# Botley West Solar Farm

## Applicant's Response to the ExA's First Written Questions

PINS Ref: EN010147

Document Ref: EN010147/APP/12.2 Rev P0

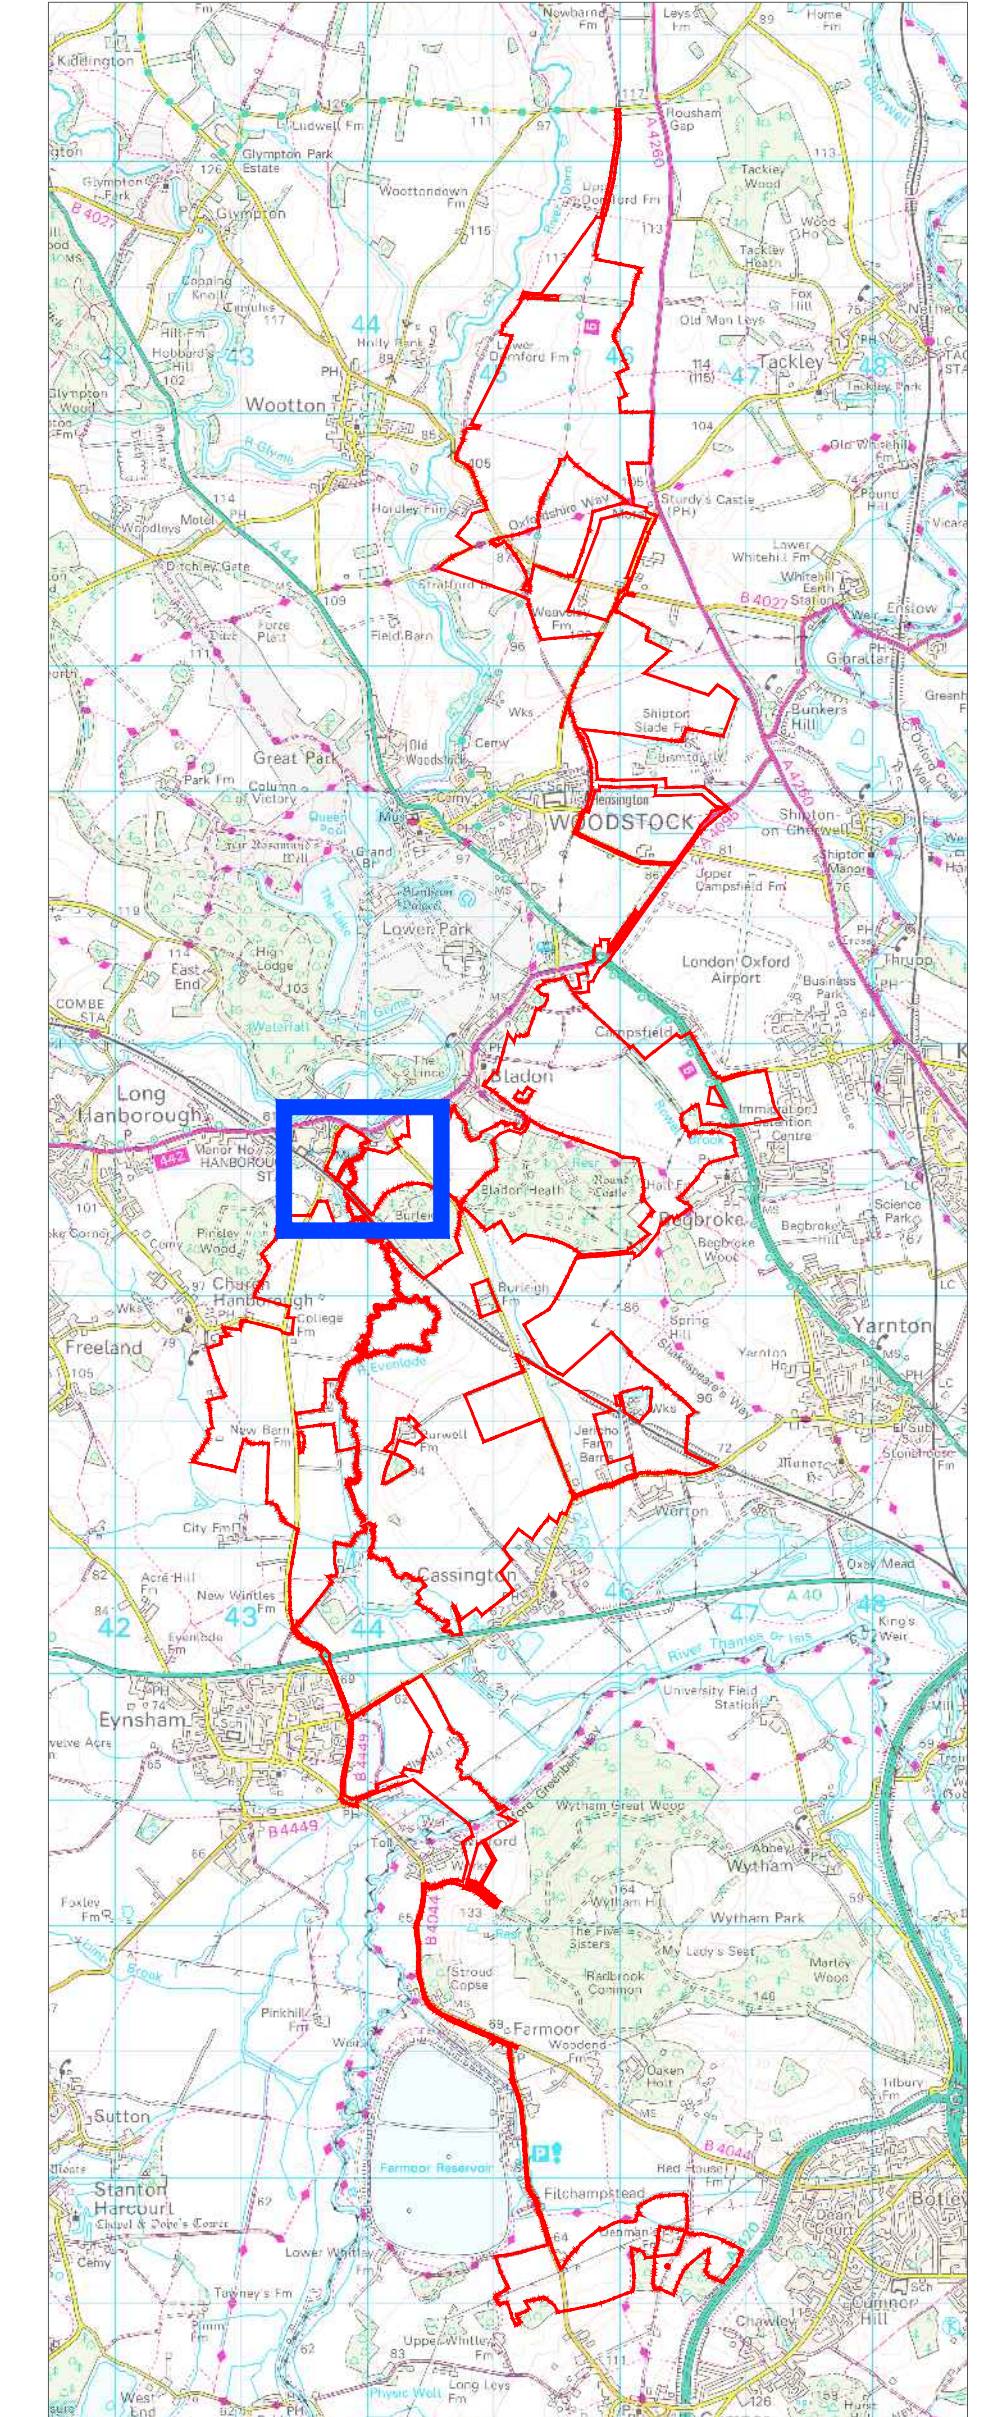
| ExQ1           | Question to | Question  | Applicant's Response   |
|----------------|-------------|---|--|
| <b>Q1.3.11</b> | Applicant   | <p><b>Mineral and waste resources</b></p> <p>The ExA notes that, in respect of sensitive archaeology deposits, the Applicant has chosen to avoid or exclude the relevant land from Order</p>  | <p>1. The proposed solar farm infrastructure covers approximately 119 ha of the mineral safeguarding area. However, approximately 2.7 ha of land within the mineral safeguarding area is intended to be removed from the proposed infrastructure area as part of a formal change request. A plan is provided in</p>  |

(3) Small reduction in redline (0.015 ha)

(2) Replace solar installation area for further archeological protection and management (0.17ha)

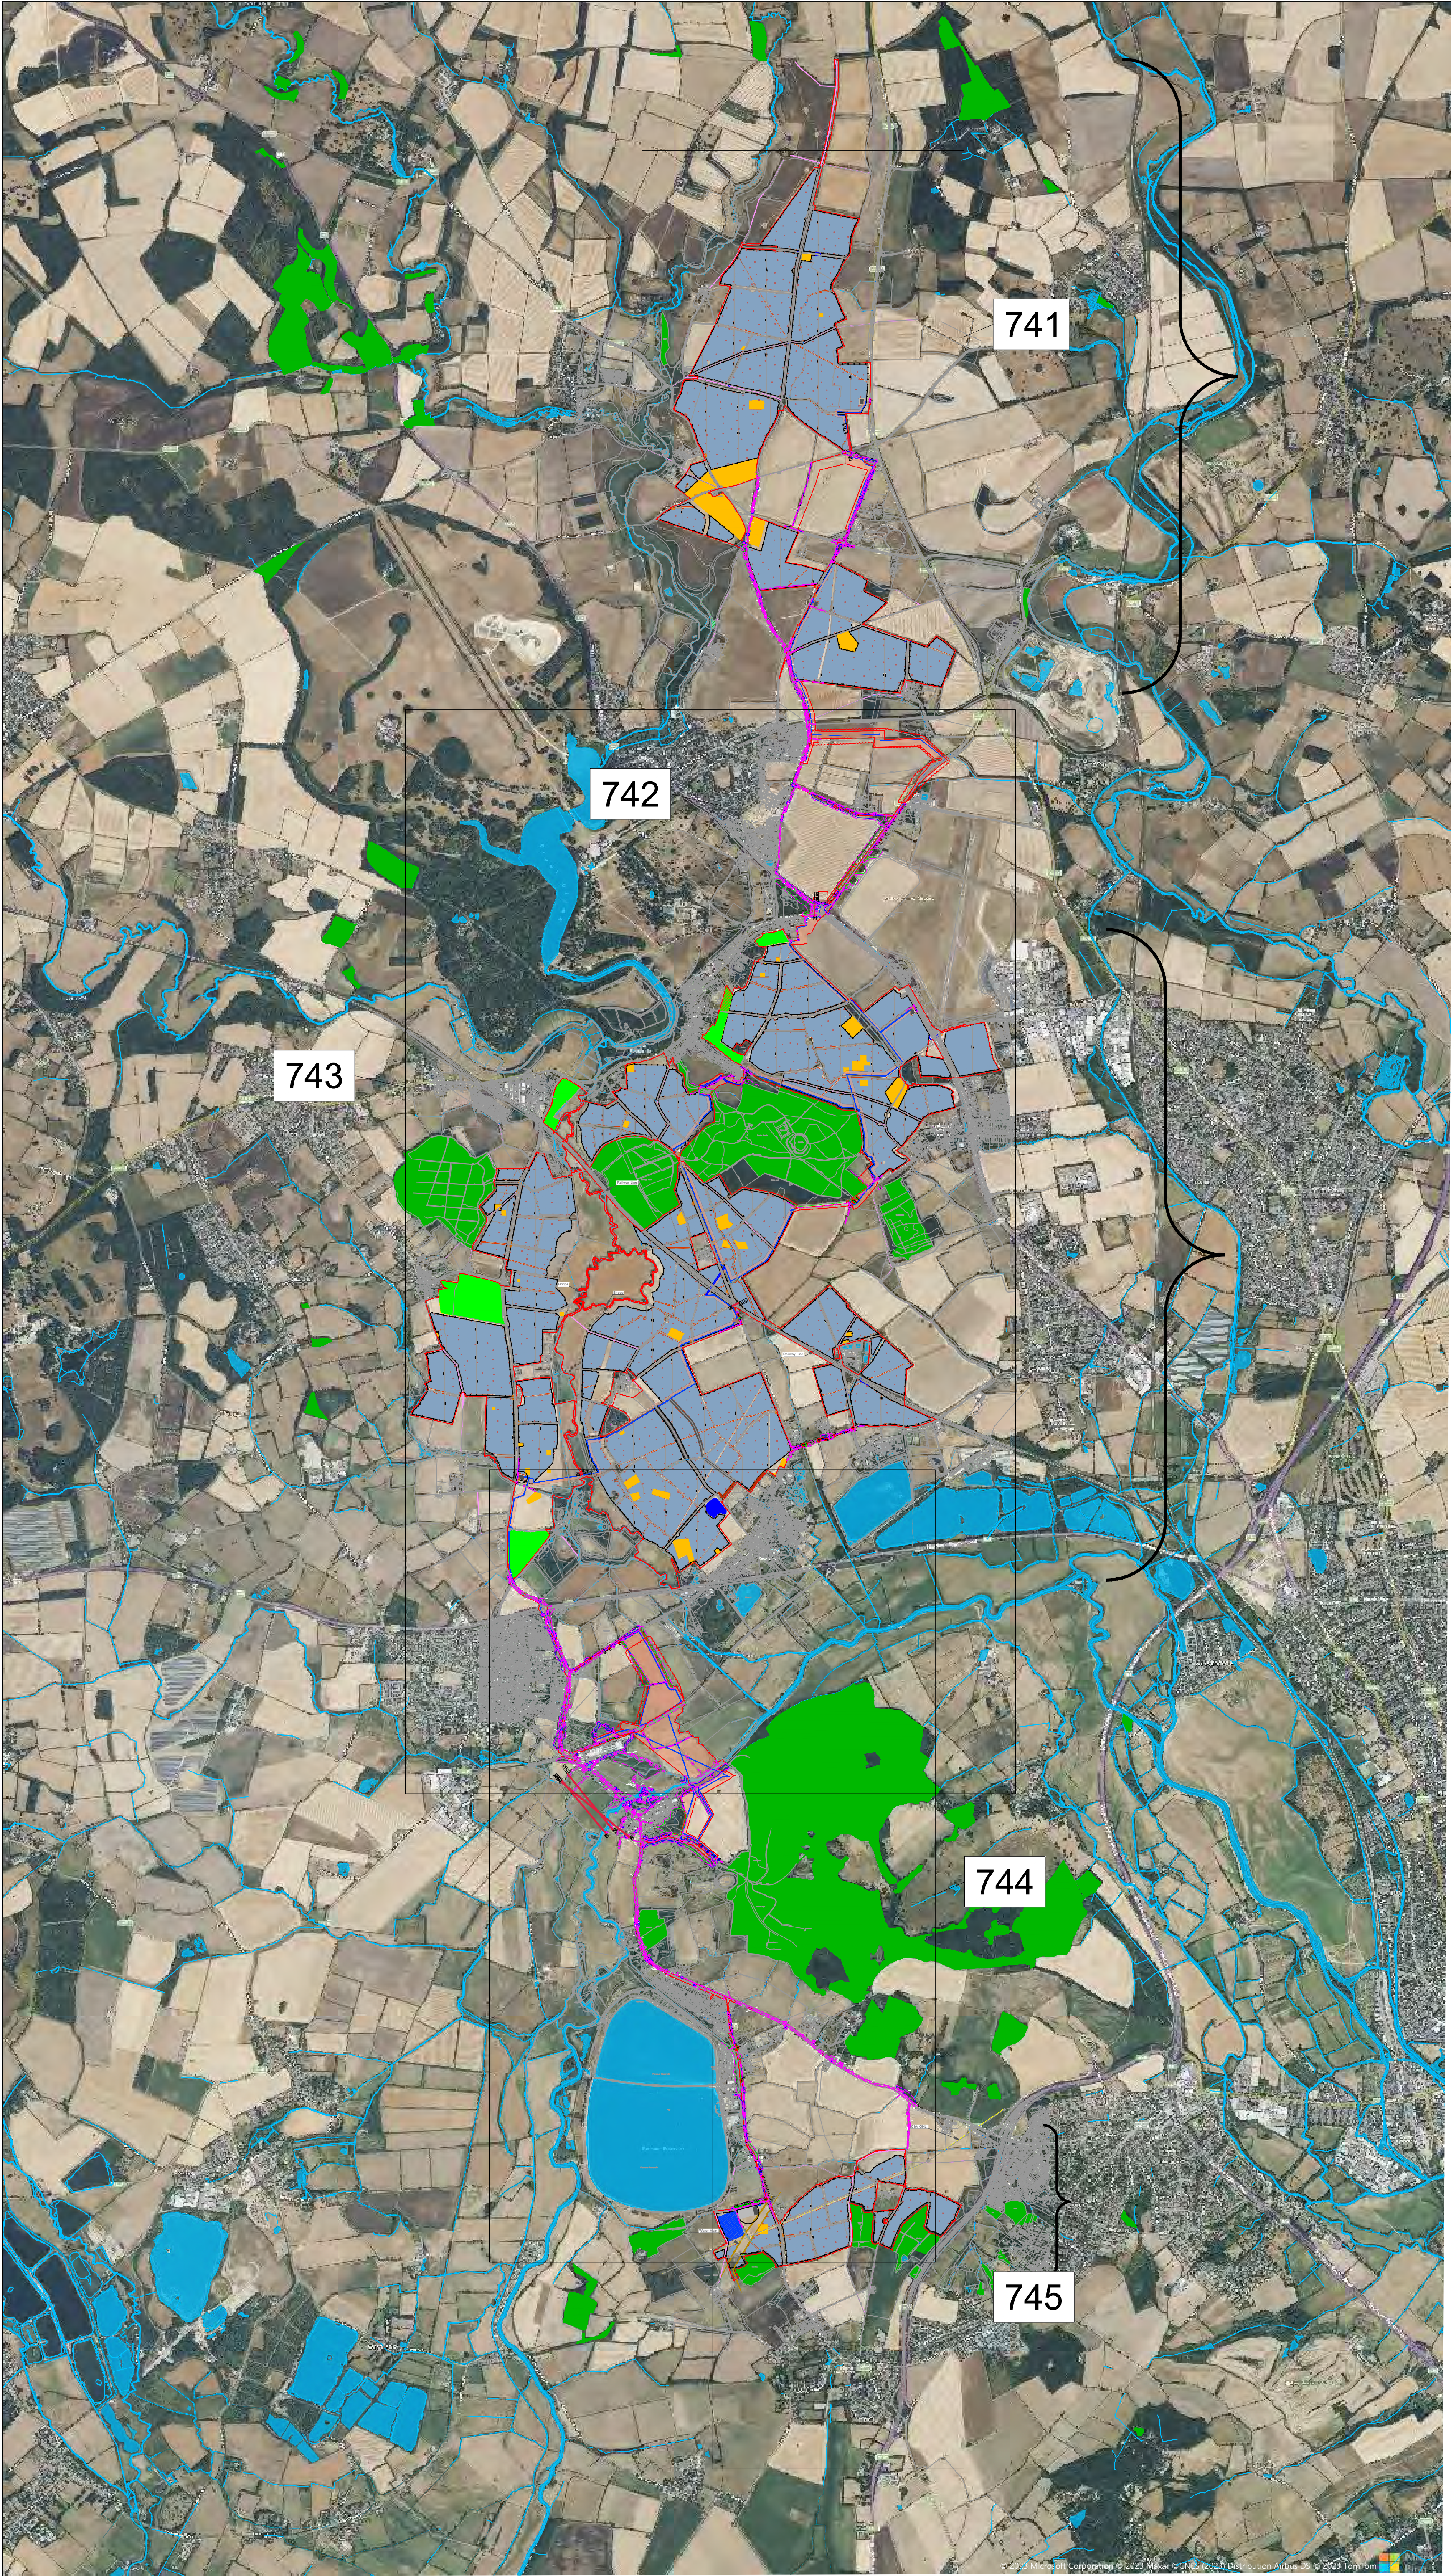
**ES Chapter 6 Project Description, indicates a maximum number of six Secondary Project Substations whereas the ES Chapter 18 states the number to be eight and ES Chapter 9 states up to eight.**

- 2.8.1 There are proposed six secondary Project Substations as indicated by the Project Description in ES Chapter 6 **[APP-043]**. References in topic chapters 18 and 9 to 'eight' and 'up to eight' Secondary Substations are erroneous attributable to an earlier layout arrangement for the Project.

- 2.8.2 For ES Chapter 18 Waste **[APP-055]**, arisings from construction and decommission have been calculated for all elements of the Project including for the Secondary Substations. The derivation of waste arising volumes for the construction and decommission of substations has been provided by the Project engineering team.
